**ADDENDUM NO. 2**

PROJECT TITLE:  
**REPLACEMENT OF  
 BRIDGE NO. 06896, ROUTE 156  
 OVER ARMSTRONG BROOK**

TOWN:  
**OLD LYME**  
 DRAWING TITLE:  
**RIGHT-OF-WAY  
 PLAN**

PROJECT NO.  
**104-175**  
 DRAWING NO.  
**ROW-1**  
 SHEET NO.  
**03.02.A2**

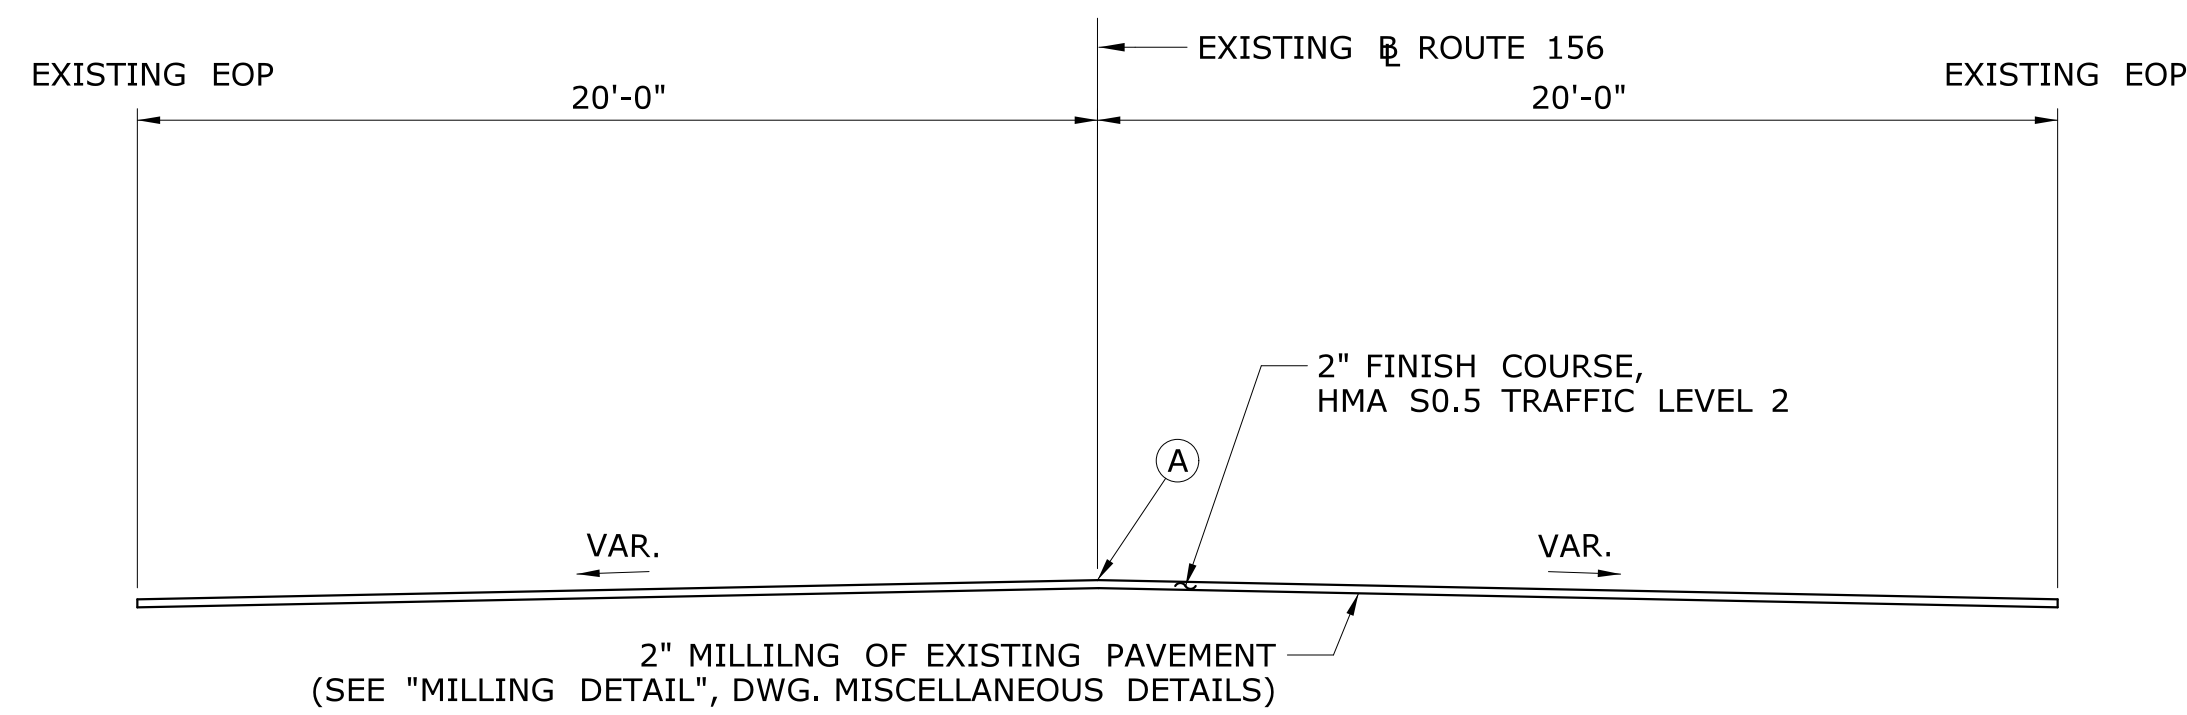
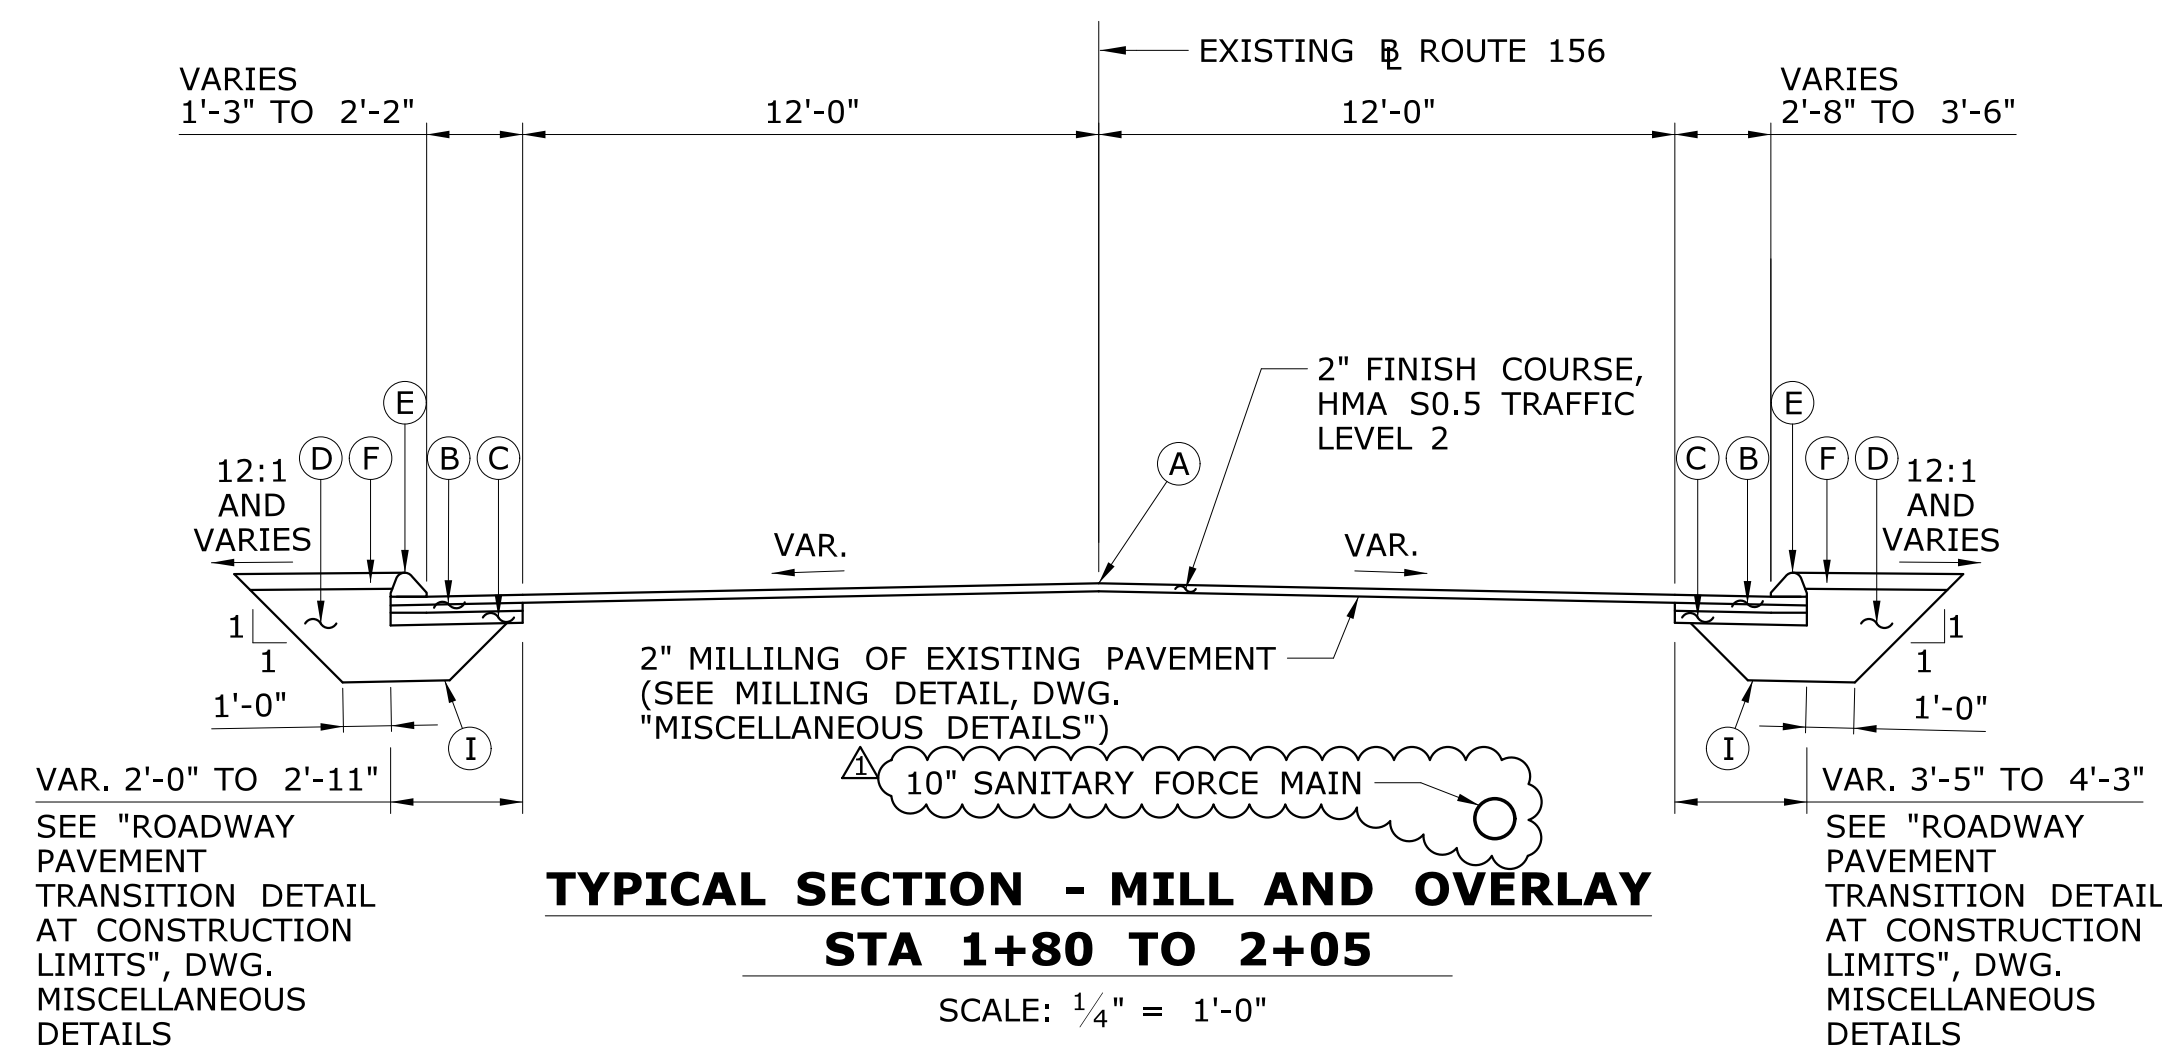
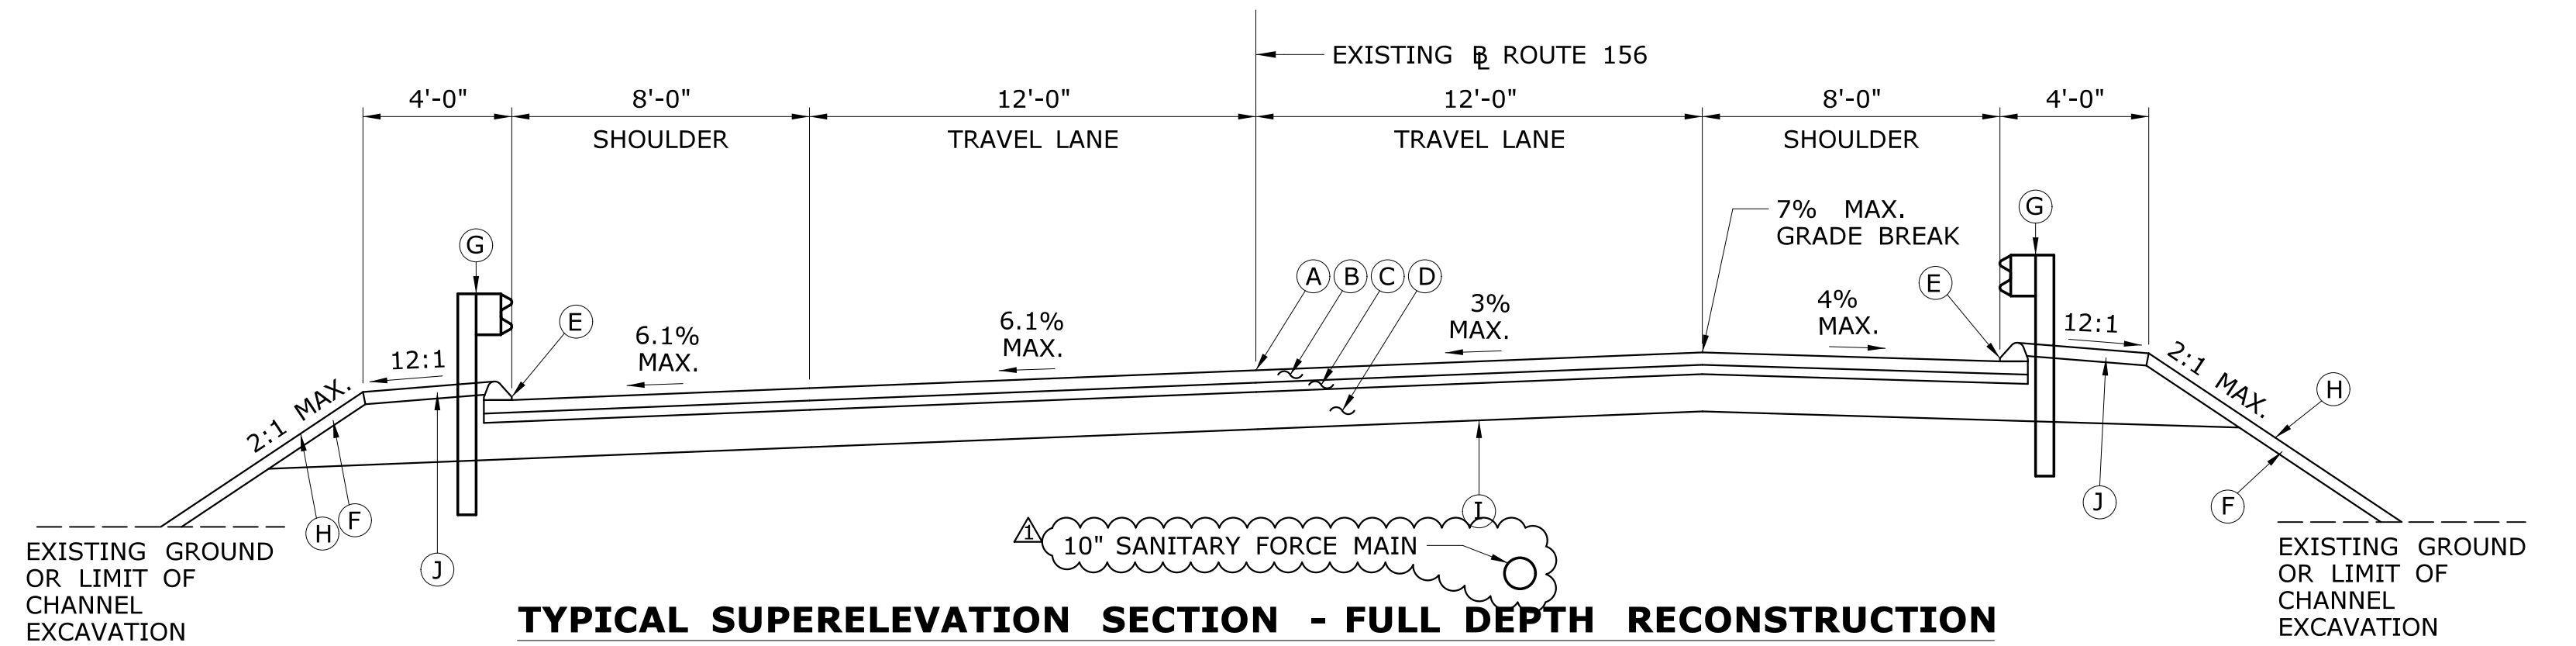
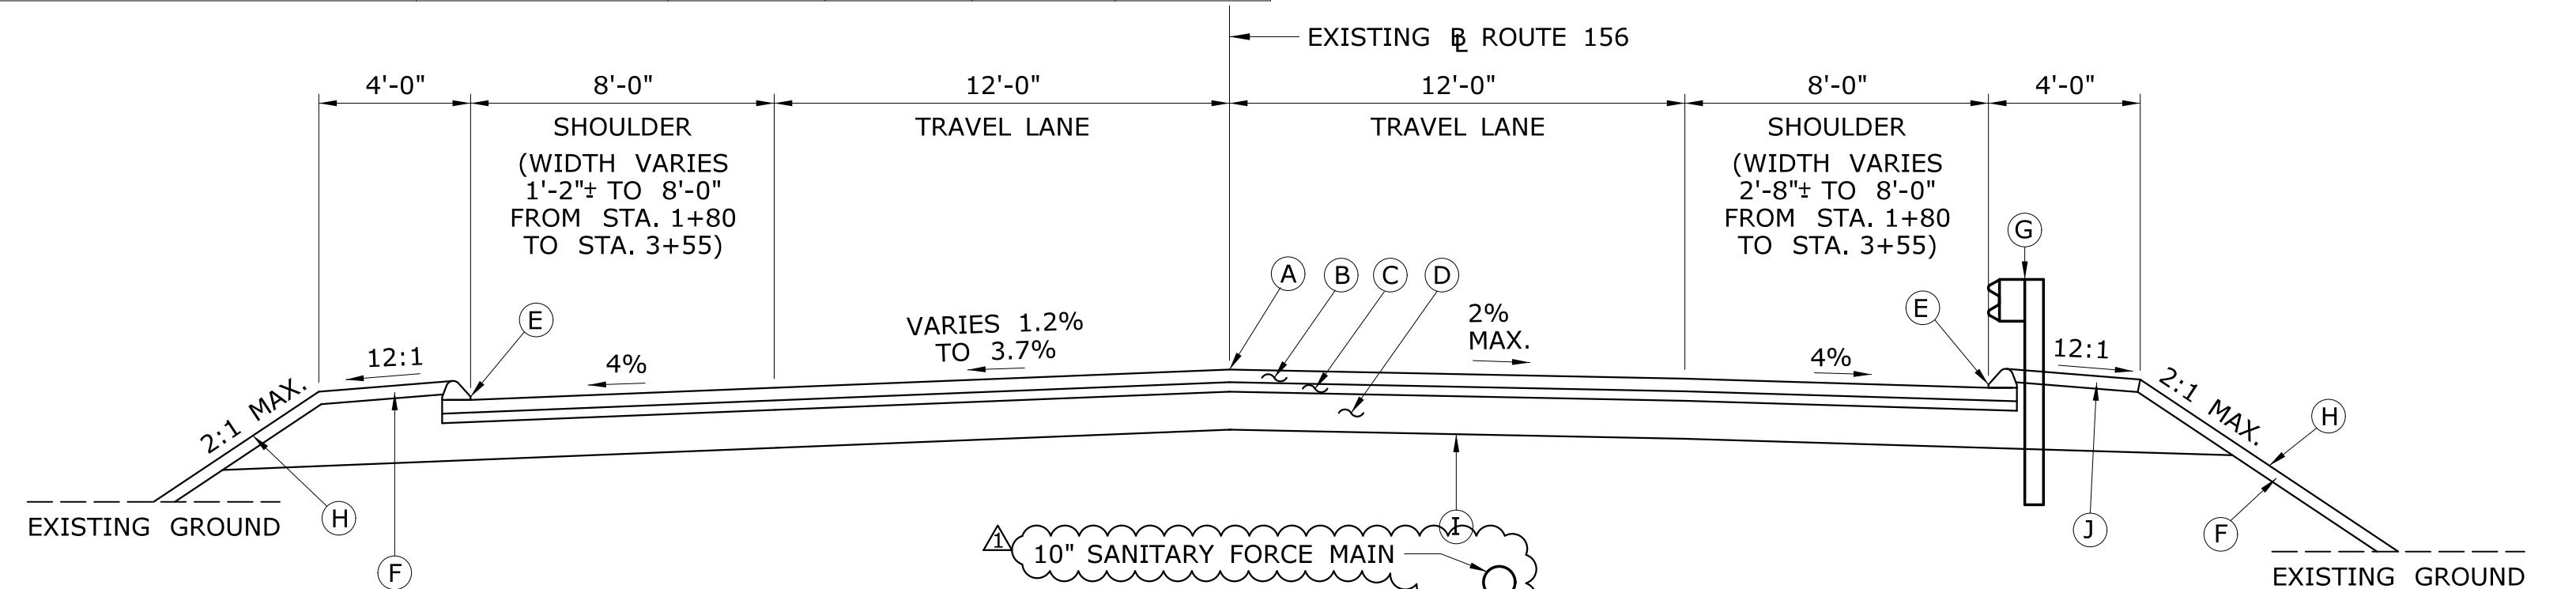
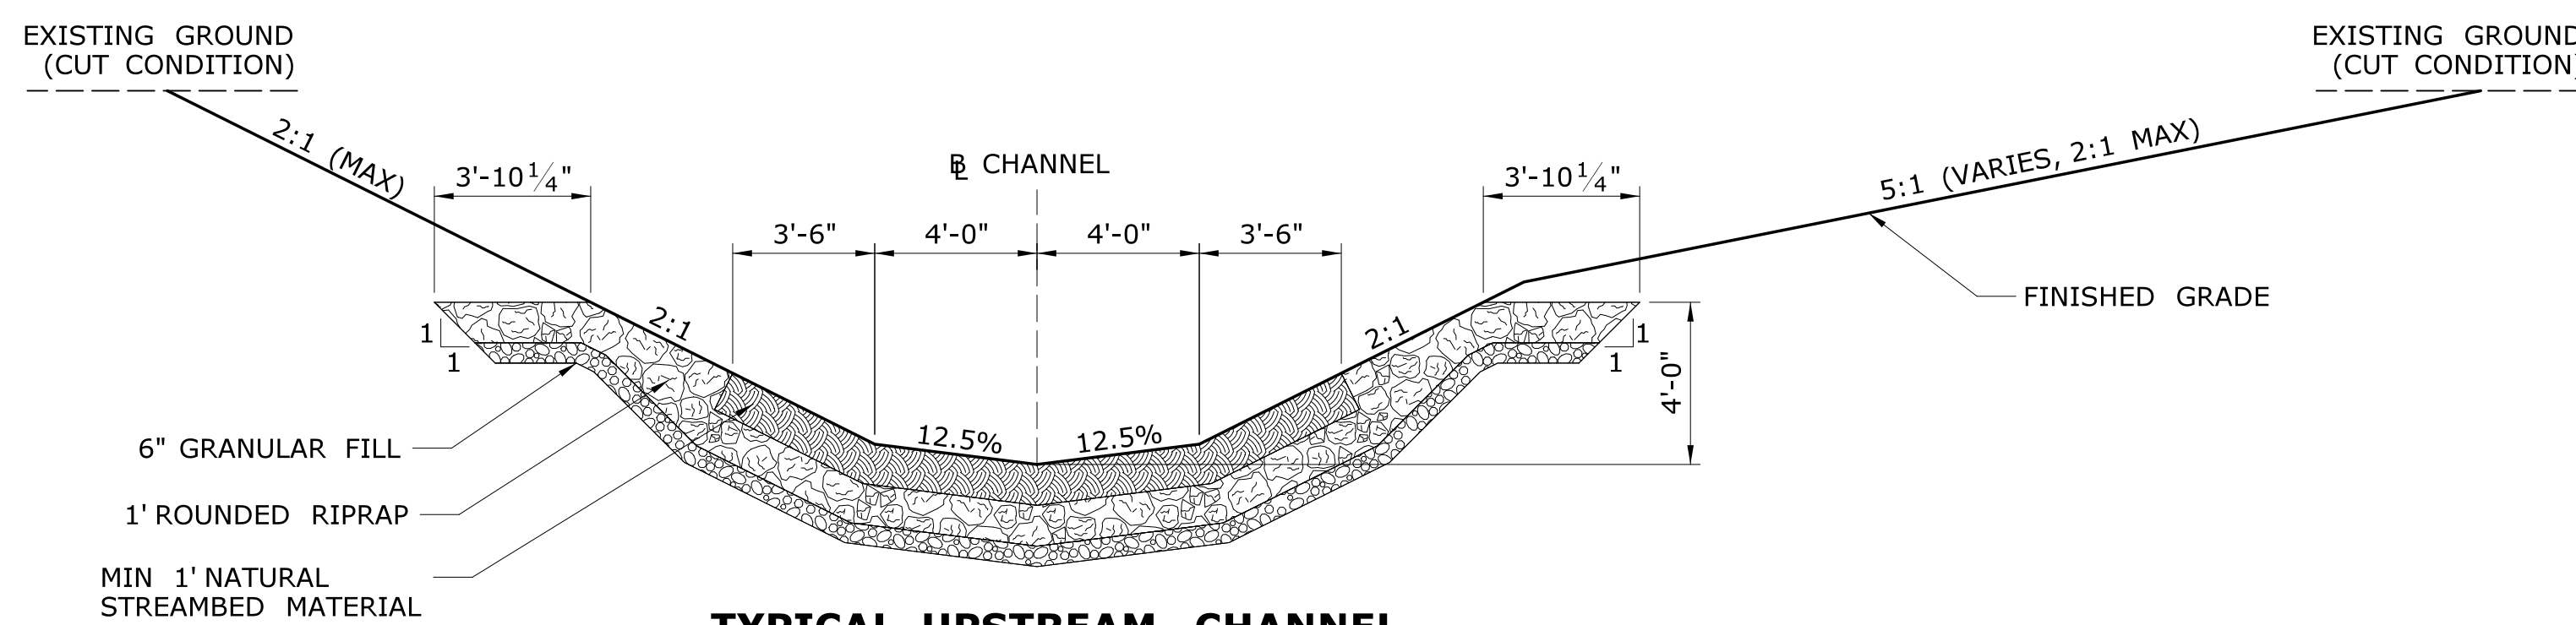
ADDENDUM NO. 2 01.31.25 REV. DATE	ADD SANITARY FORCE MAIN REVISION DESCRIPTION	03.03 SHEET NO.	THE INFORMATION, INCLUDING ESTIMATED QUANTITIES OF WORK, SHOWN ON THESE SHEETS IS BASED ON LIMITED INVESTIGATIONS BY THE STATE AND IS IN NO WAY WARRANTED TO INDICATE THE CONDITIONS OF ACTUAL QUANTITIES OF WORK WHICH WILL BE REQUIRED. Plotted Date: 2/6/2025	DESIGNER/DRAFTER: <b>M. STOYF/ N. ROSSI</b> CHECKED BY: <b>S. ROSE</b> SCALE IN FEET 0 40 80 SCALE 1"=40' Filename: ...VHW_MSH_0104_0175_(03)_Br06896_PLAN.dgn	 <b>STATE OF CONNECTICUT</b> <b>DEPARTMENT OF TRANSPORTATION</b> 	SIGNATURE/ BLOCK:  PROJECT TITLE: <b>REPLACEMENT OF          BRIDGE NO. 06896, ROUTE 156          OVER ARMSTRONG BROOK</b>	TOWN: <b>OLD LYME</b> DRAWING TITLE: <b>ROADWAY          PLAN</b>	PROJECT NO. <b>104-175</b> DRAWING NO. <b>PLN-01</b> SHEET NO. <b>03.03.A2</b>
---	---	--------------------	---	---	--	--	--	---
